SERVICE BULLETIN REVISION TRANSMITTAL SHEET

Service Bulletin No. 700-24-7507

Revision No. 02 Dated Oct 16/2023

MODIFICATION – DC POWER CONVERSION – TRANSFORMER RECTIFIER UNIT (TRU) FAN CIRCUIT, PBIT, CBIT AND TURN-ON THRESHOLD CORRECTION

Figure 1 – Removal and discard of the insulation blanket.
(Sheet 1 of 2)

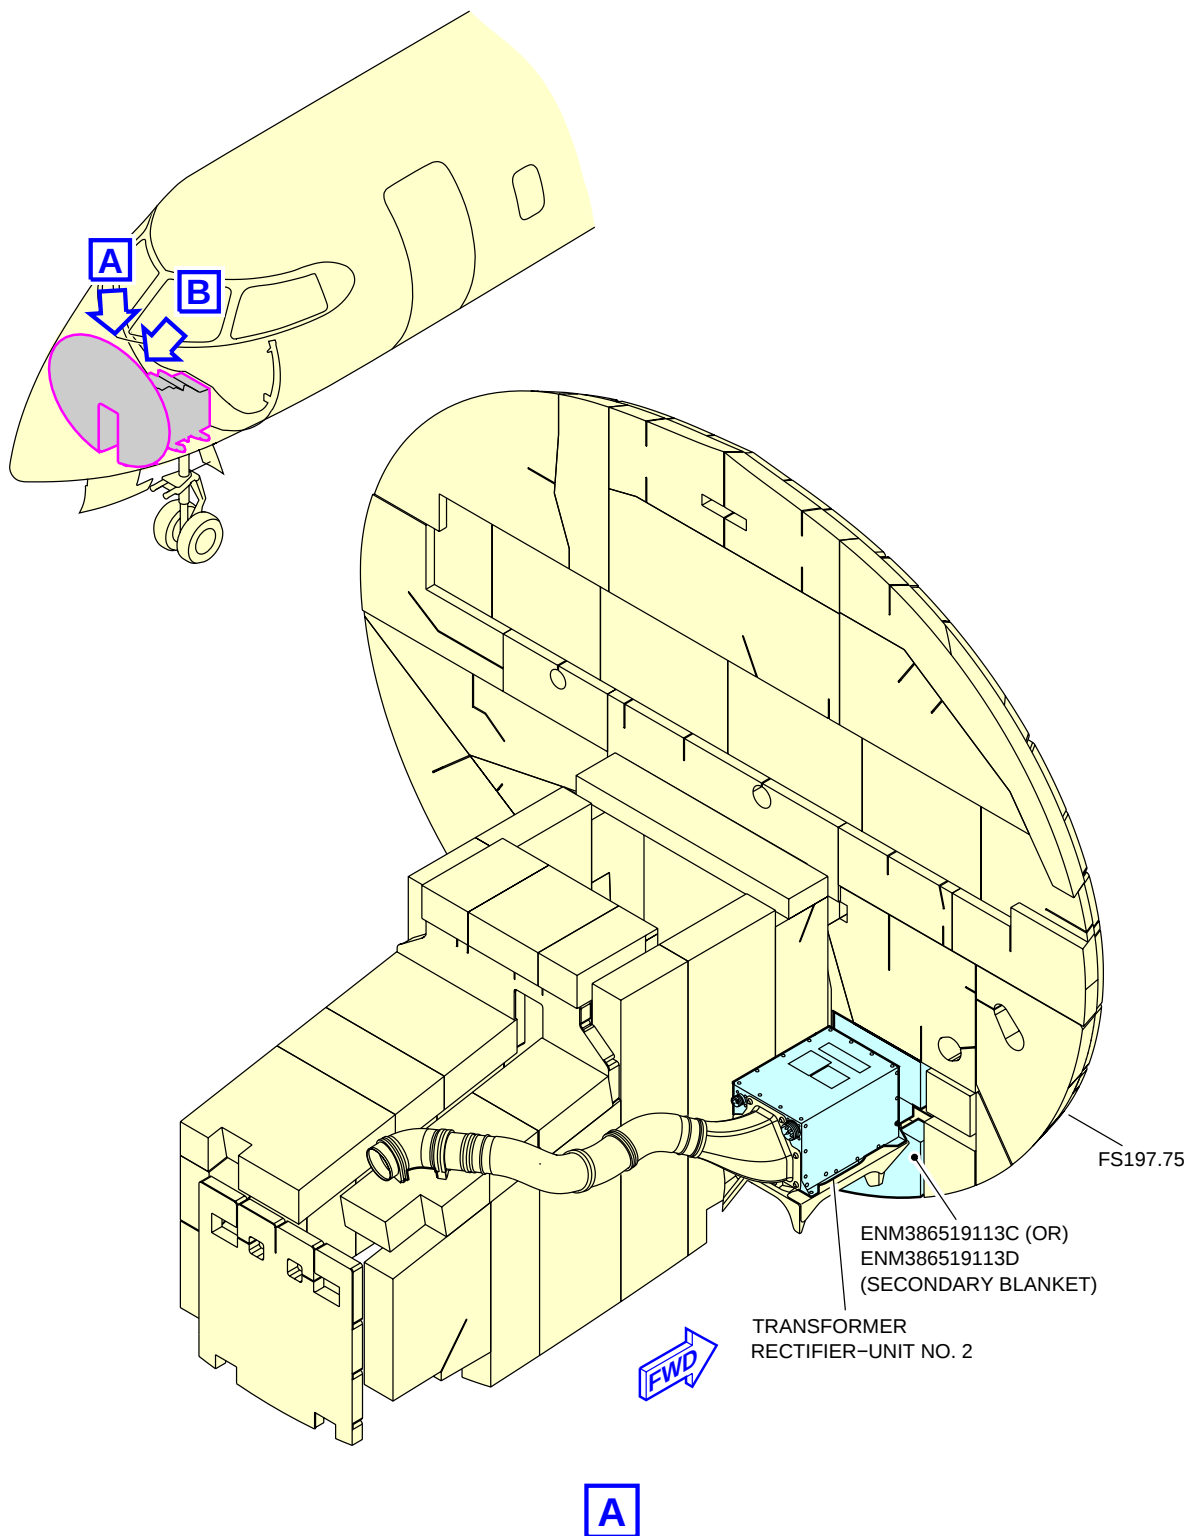
1. Change, in Paragraph 1.K. .Modification Summary, R700T7400477 to Rev.B and add drawing GK2580002, Rev. A.
2. Add, in Paragraph 2.B.(2) and in Figure 1, the part no. ENM386519113C for the secondary blanket.
3. Make miscellaneous minor changes, as necessary, with no change of context.

Remove and discard the secondary layer of insulation blanket in front of the TRU 2 fan air inlet in the cockpit underfloor RHS, as shown in Paragraph 2.B.(2).

- (1) Remove the TRU No. 2 per BD700-A-J24-31-03-00AAA-520A-A.
- (2) At FS 197.75, pressure bulkhead, remove and discard the secondary insulation blanket (part no. ENM386519113C or ENM386519113D) as shown in Figure 1.
 - (a) Re-identify the blanket installation by ink stamp per best shop practice.
- (3) Install the new TRU No. 2 Part No. G02404521-003. Refer to BD700-A-J24-31-03-00AAA-720A-A.
 - (a) Do a check of the electrical bond resistance on the TRU. Refer to BD700-AJ51-80-00-00AAA-366A-A.

Figure 1 – Removal and discard of the insulation blanket.
(Sheet 2 of 2)

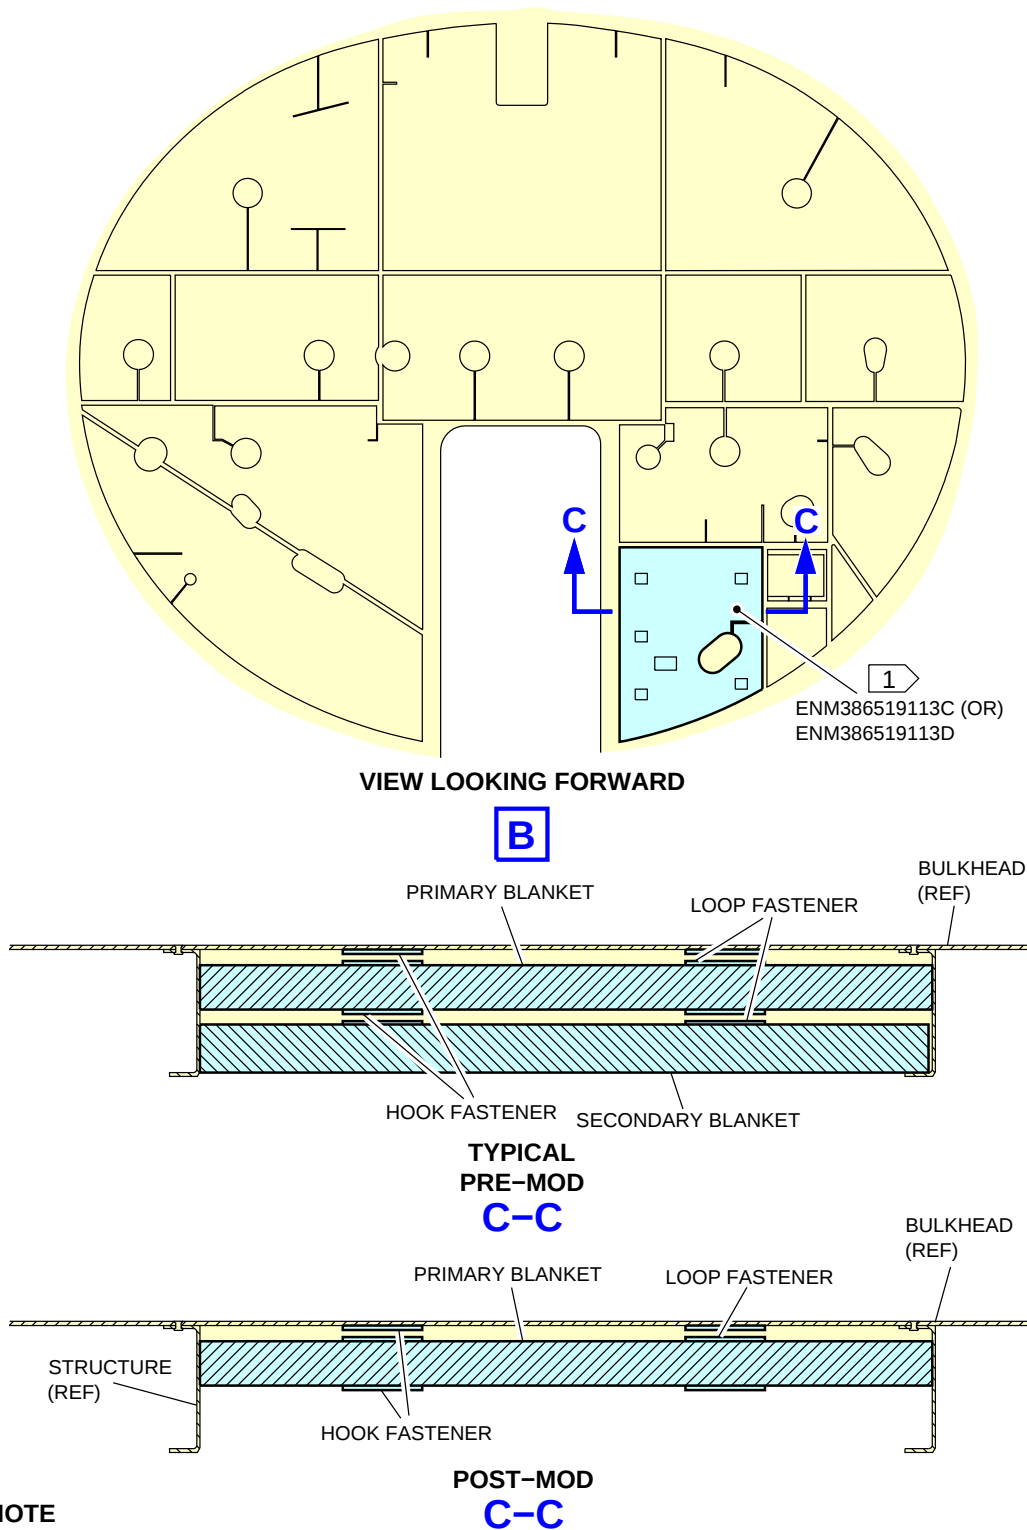
- 1 Remove and discard the secondary blanket.
